Proposal for amendments to Regulation No. 79 (Steering equipment)

Proposed changes with regard to the implementation of technical specifications for Lane Departure Warning Systems (LDWS)

Model A

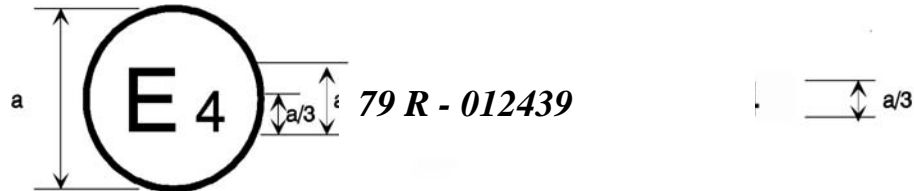
The above approval mark affixed to a vehicle shows that the vehicle type concerned has, with regard to steering equipment, been approved in the Netherlands (E4) pursuant to Regulation No. 79 under approval No. 012439. The approval number indicates that the approval was granted in accordance with the requirements of Regulation No. 79 incorporating the 01 series of amendments. ***In the case the requirement of Annex 7 are also fulfilled shall the letter “R” a number “7” in brackets following***
